LR-N00-0387  
LCR S00-06

**REQUEST FOR LICENSE AMENDMENT  
INCREASED LICENSED POWER LEVEL  
SALEM GENERATING STATION, UNIT NOS. 1 AND 2  
FACILITY OPERATING LICENSE DPR-70 AND DPR-75  
DOCKET NOS. 50-272 AND 50-311**

**ATTACHMENT 1  
SALEM GENERATING STATION  
UNIT NOS. 1 AND 2  
FACILITY OPERATING LICENSE DPR-70 AND DPR-75  
DOCKET NOS. 50-272 AND 50-311  
CHANGE TO TECHNICAL SPECIFICATIONS  
INCREASED LICENSED POWER LEVEL**

FIGURE 2.1-1 REACTOR CORE SAFETY LIMIT - FOUR LOOPS IN OPERATION

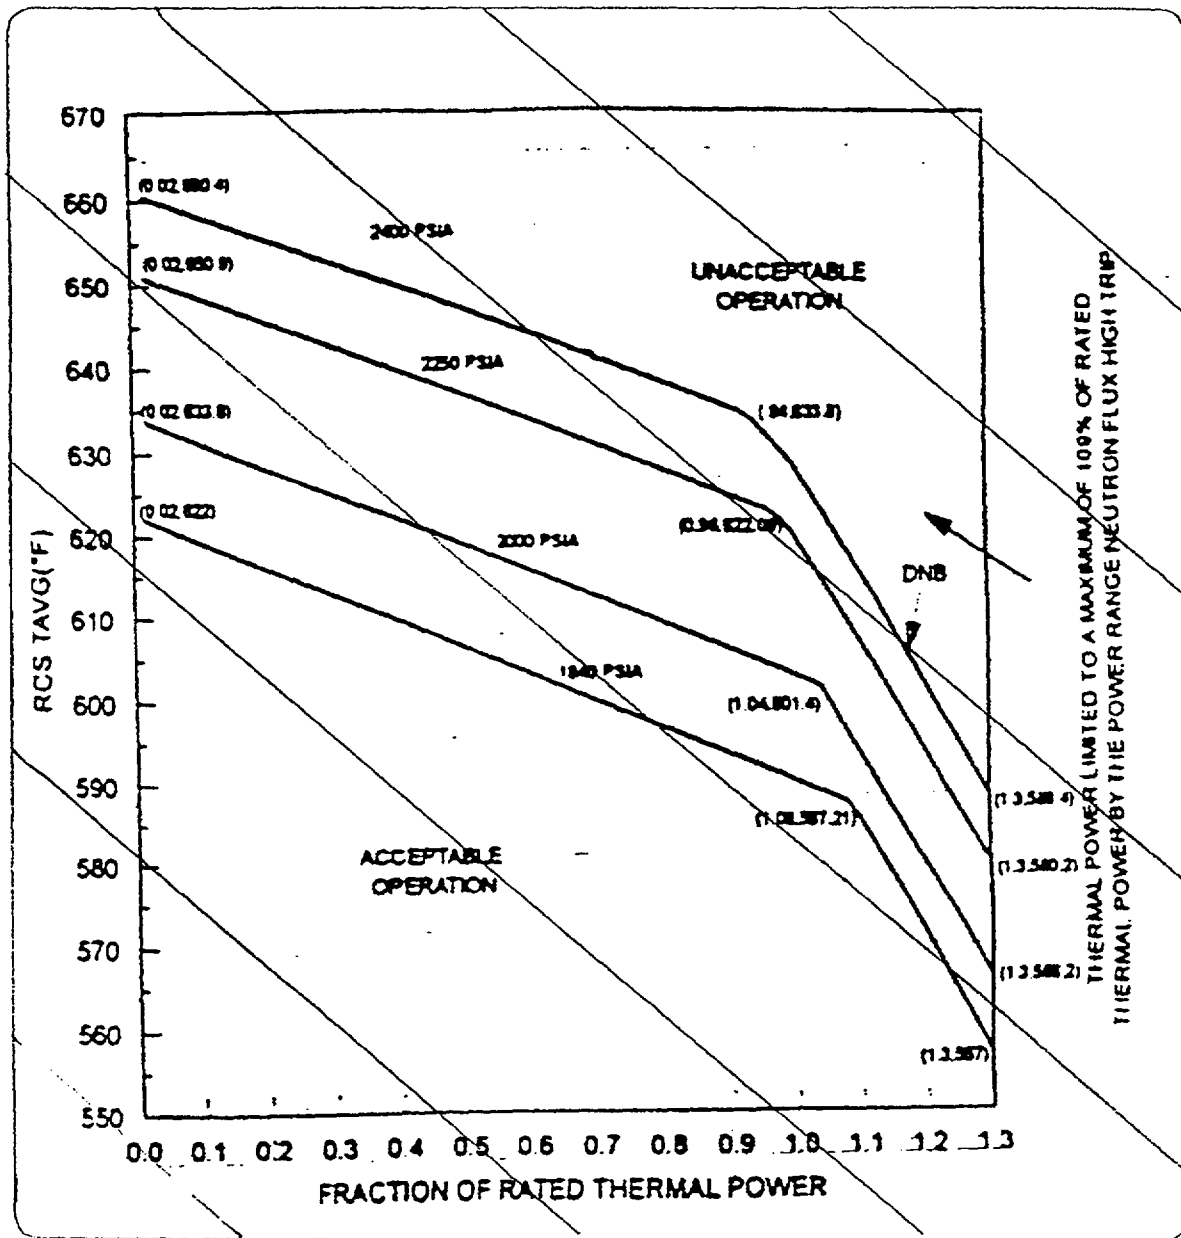
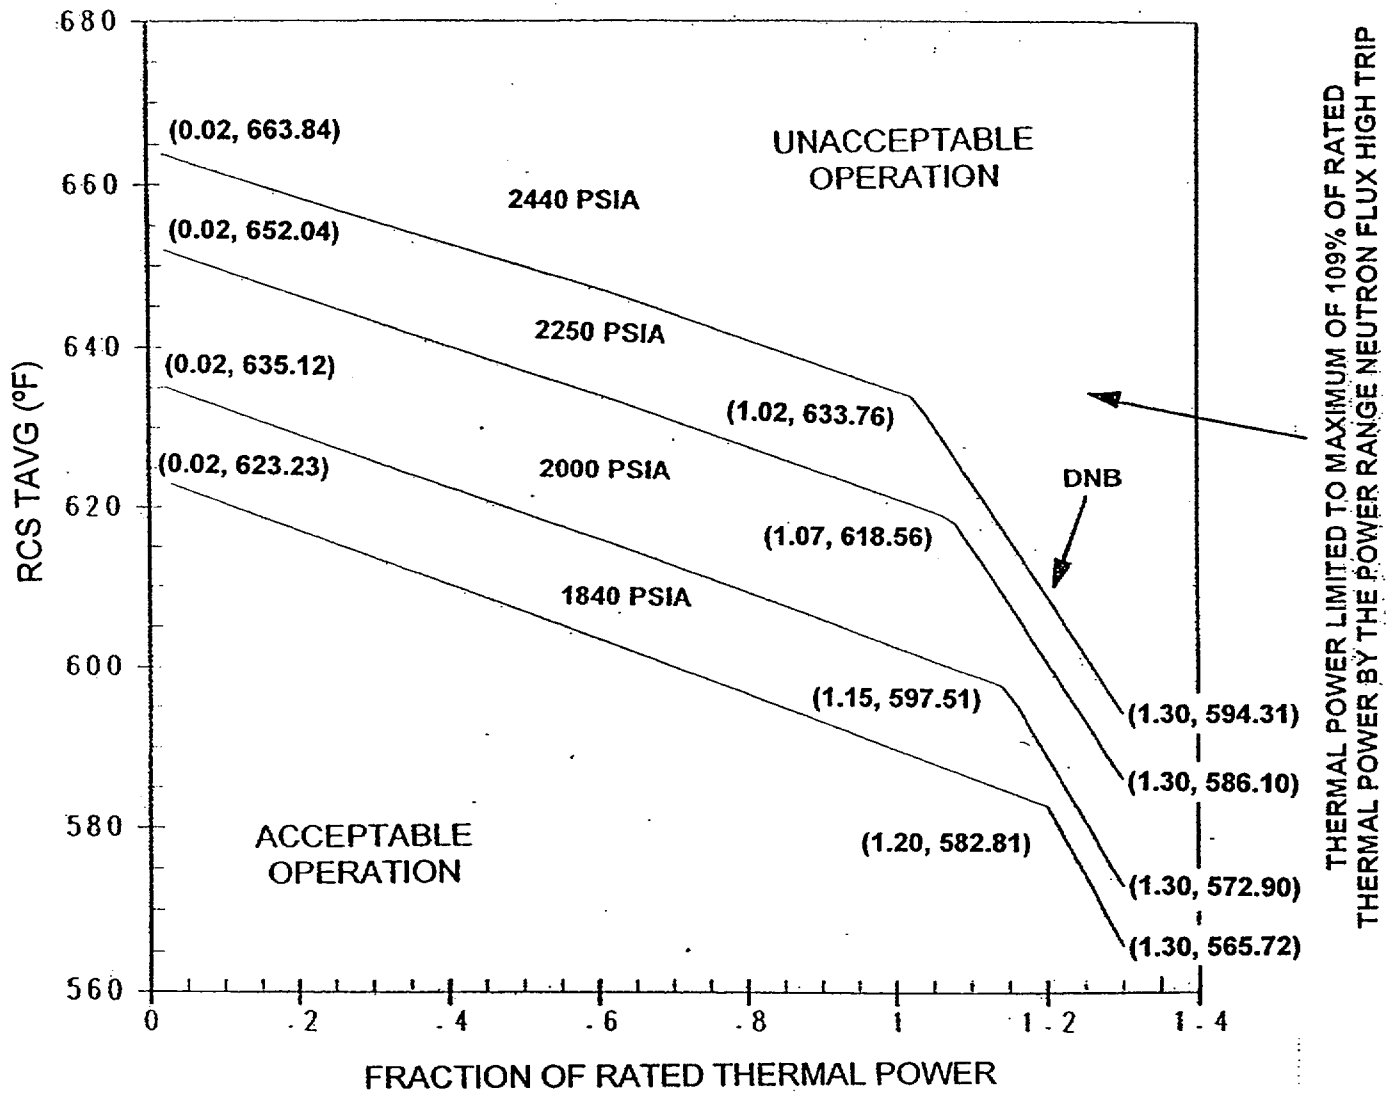
1. Technical Specification Figure 2.1-1, Reactor Core Safety Limit, is revised to reflect the new safety limits required to prevent core exit boiling at the new core power of 3459 MWt.
2. The Overtemperature  $\Delta T$  (OT $\Delta T$ ) f( $\Delta I$ ) penalties in Technical Specification Table 2.2-1, Reactor Trip System Instrumentation Trip Setpoints, are revised to support the increase in core power.

# INSERT A2

Figure 3.4-2

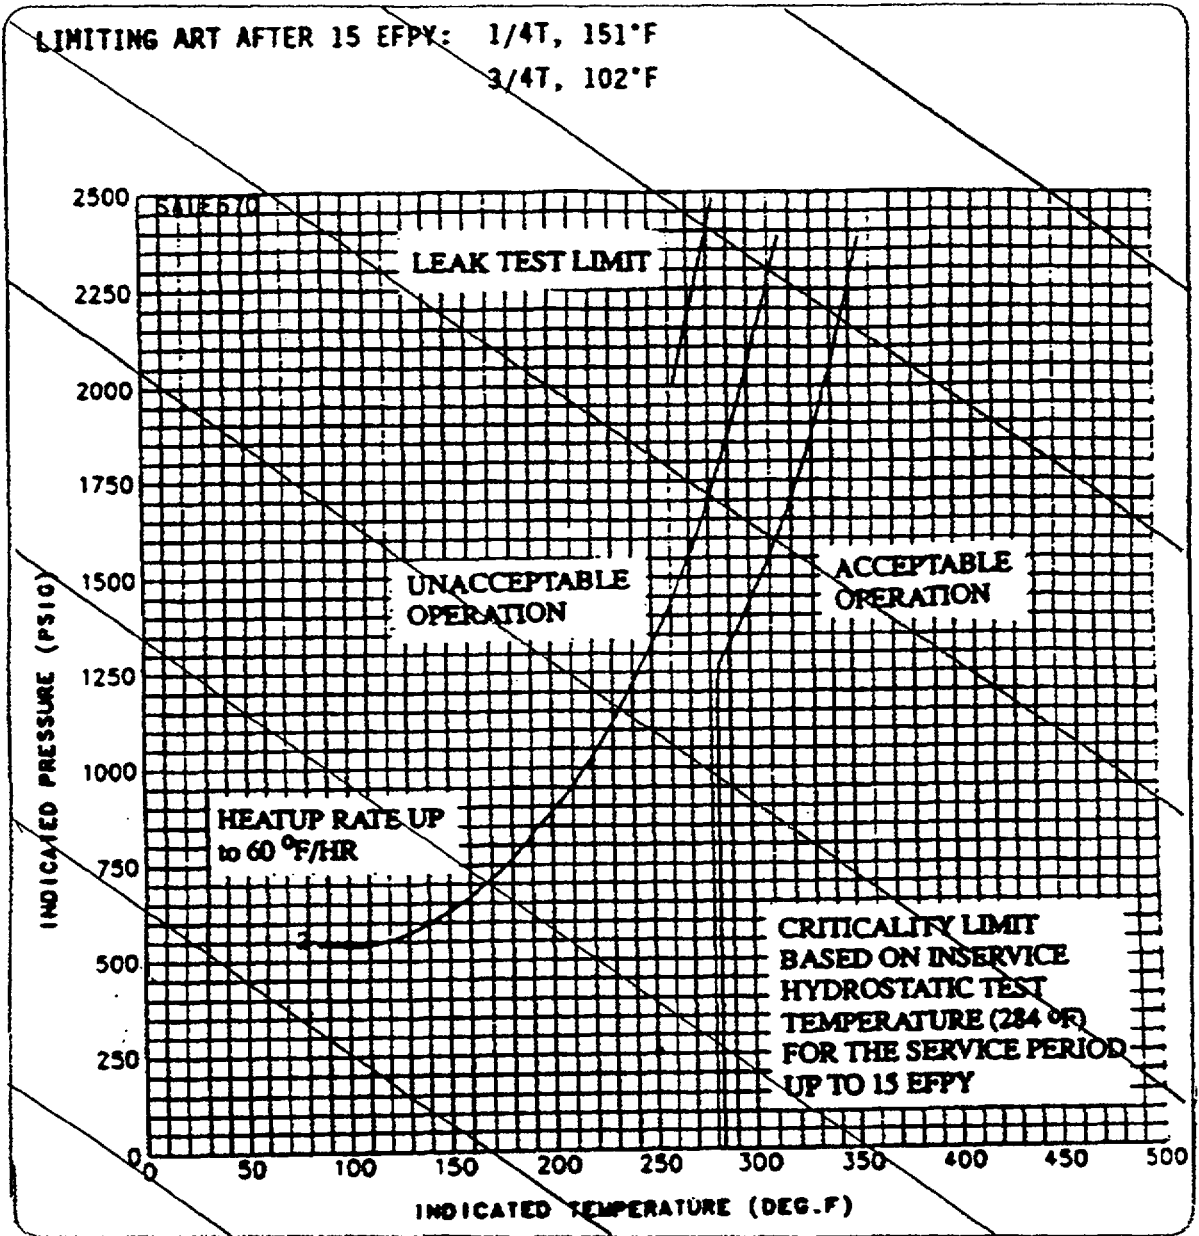
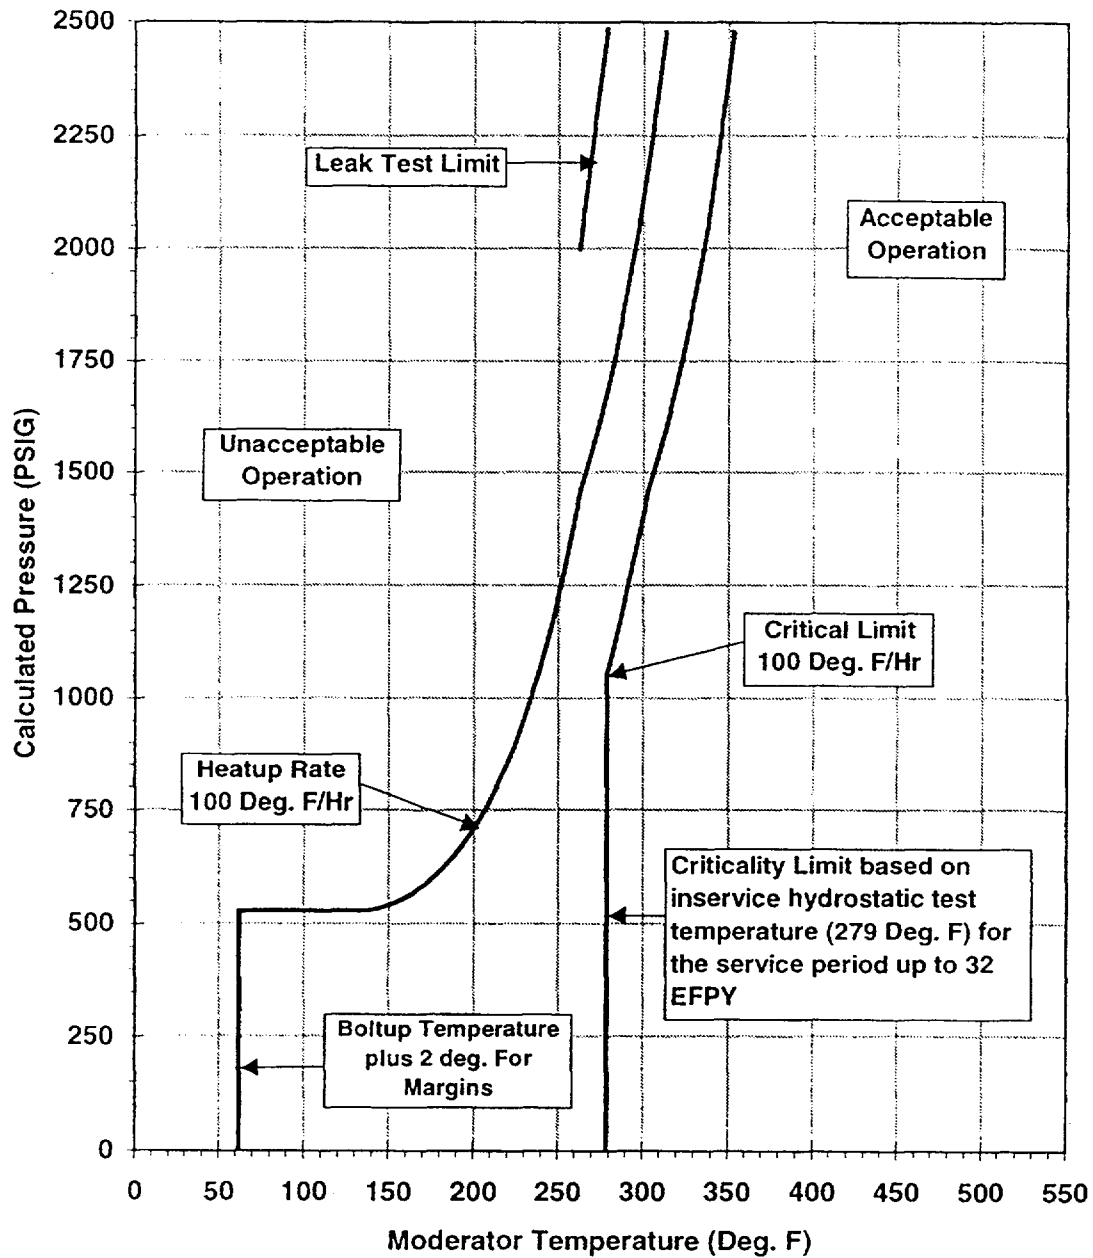
1. Technical Specification Figures 3.4-2 and 3.4-3, Reactor Coolant System Heatup and Cooldown Curves, and their associated Bases are revised to

New heatup and cooldown curves were developed for the Salem Units 1 and 2 reactor vessels based on the uprated fluence projection at 32 effective full-power years (EFPY). The maximum heatup rate for TS Figure 3.4-2 is being changed from 60°F/hr to 100°F/hr. This heatup rate change is consistent with the current Technical Specification LCO 3.4.9.1.a for Unit 1, LCO 3.4.10.1.a for Unit 2, the heatup cyclic limits of TS Table 5.7-1, and the Analysis of Record. The revised curves are being adjusted to account for pressure and temperature instrument uncertainties. Minimum boltup temperature is shown.

$RT_{NDT}$  after 32 EFPY: 1/4T 199°F  
3/4T 140°F

FIGURE 2 3/4.4-1

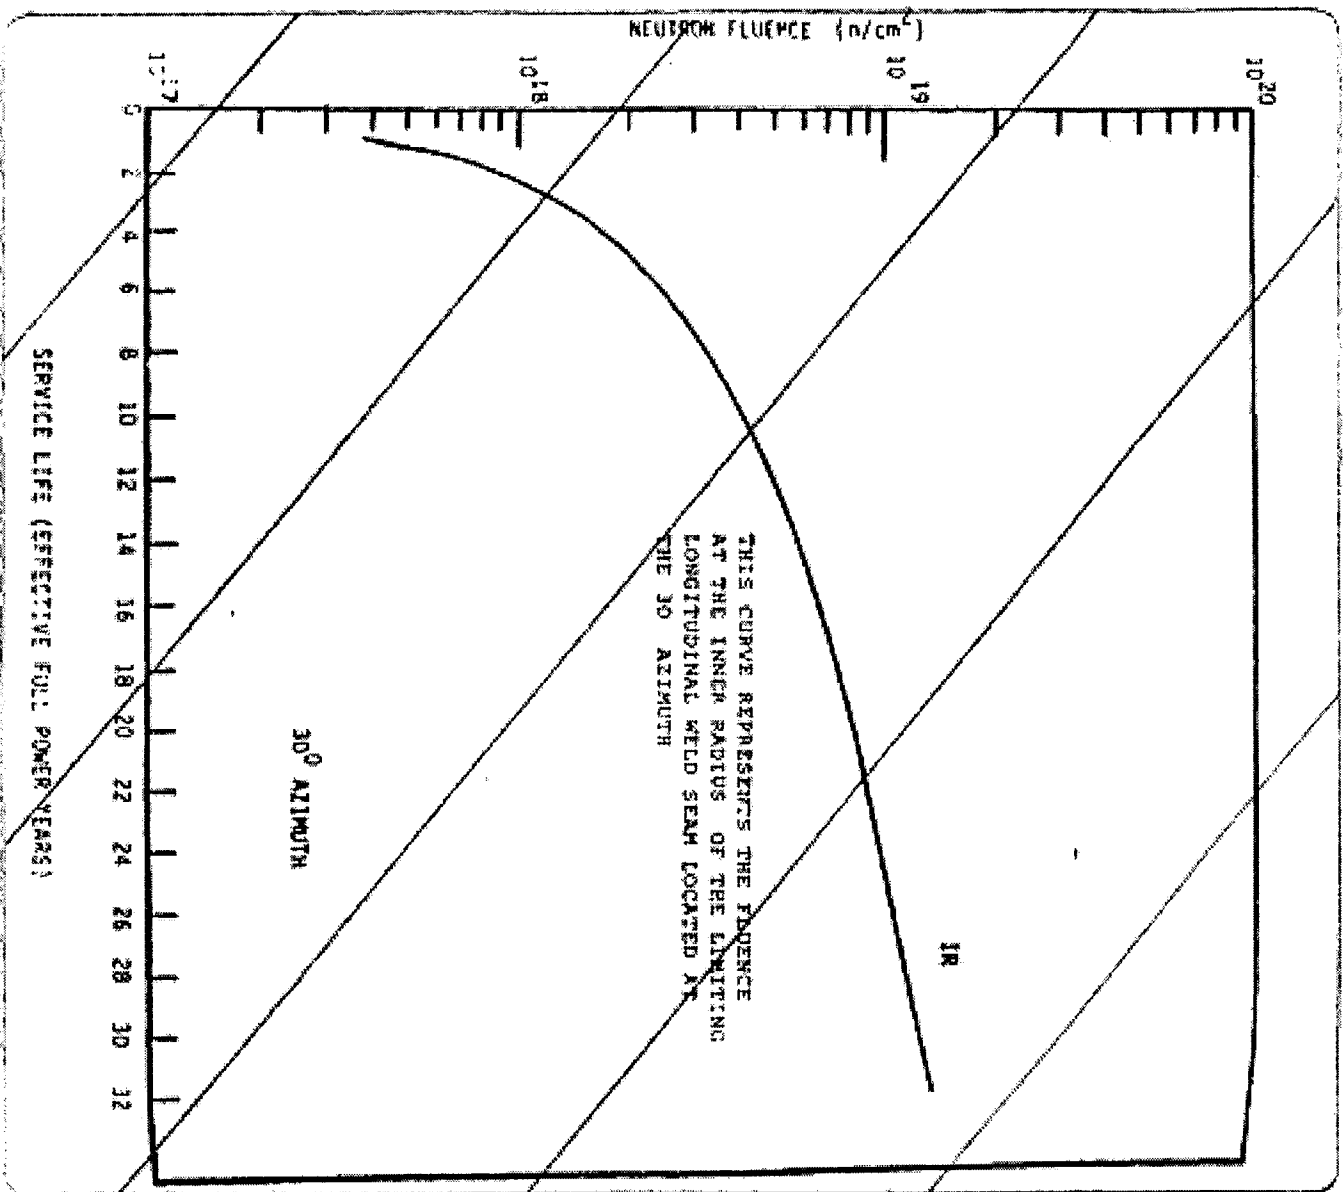
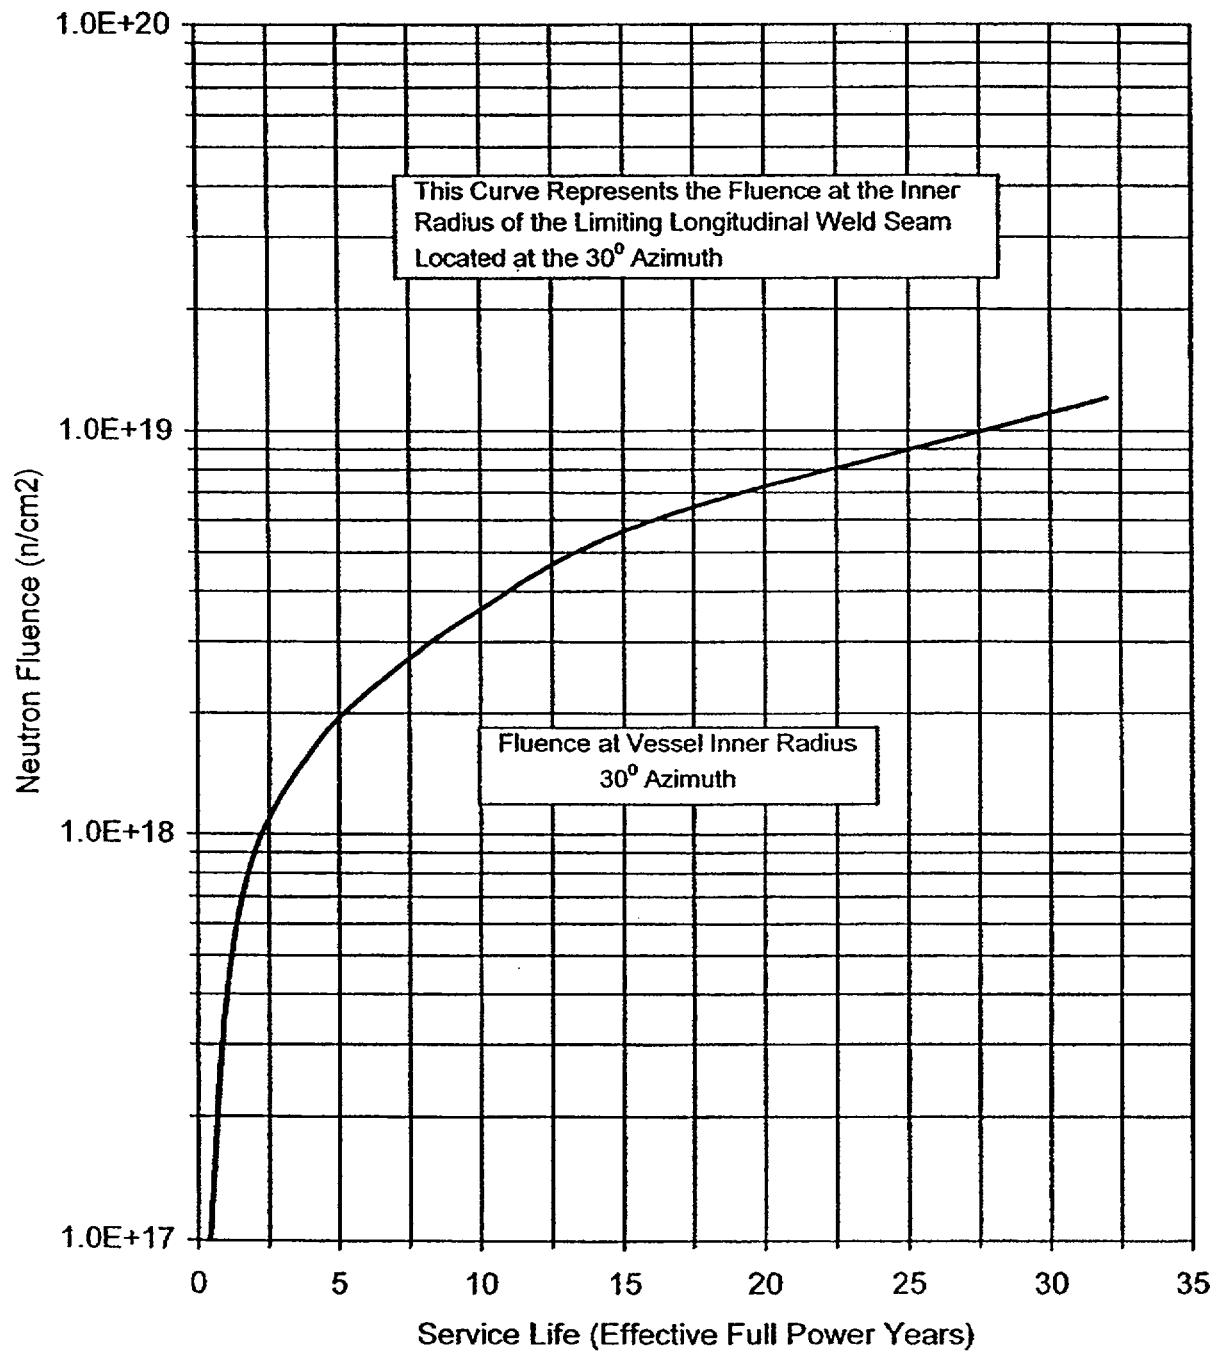
1. In TS Bases 3/4.4.9, references to ASME Boiler and Pressure Vessel Code, Section III, Appendix G are being changed to Section XI, Appendix G which is the correct reference for requirements related to reactor vessel pressure-temperature limits.
2. In TS Bases 3/4.4.9, corrections are being made to the symbol " $\Delta RT_{NDT}$ " in cases where the symbol is represented incorrectly.
3. In TS Bases 3/4.4.9, a reference to Figure B3/4.3-1 is being revised to the correct number, Figure B3/4.4-1.

The results of the fast neutron exposure evaluations for Salem Units 1 and 2 account for the uprated power level. The results are based on the conservative assumption that the power uprate was initiated coincident with the last surveillance capsule withdrawal from each unit. The resulting fast neutron ( $E > 1.0$  MeV) exposure projections increased due to the power uprate. The new projections were used as input to the reactor vessel integrity evaluations. TS Bases Figure 3/4.4-1 shows predicted fluence as a function of Effective Full Power Years. The results of the fast neutron exposure evaluation are incorporated in the revised figures in Attachment 4.

## INSERT E 2
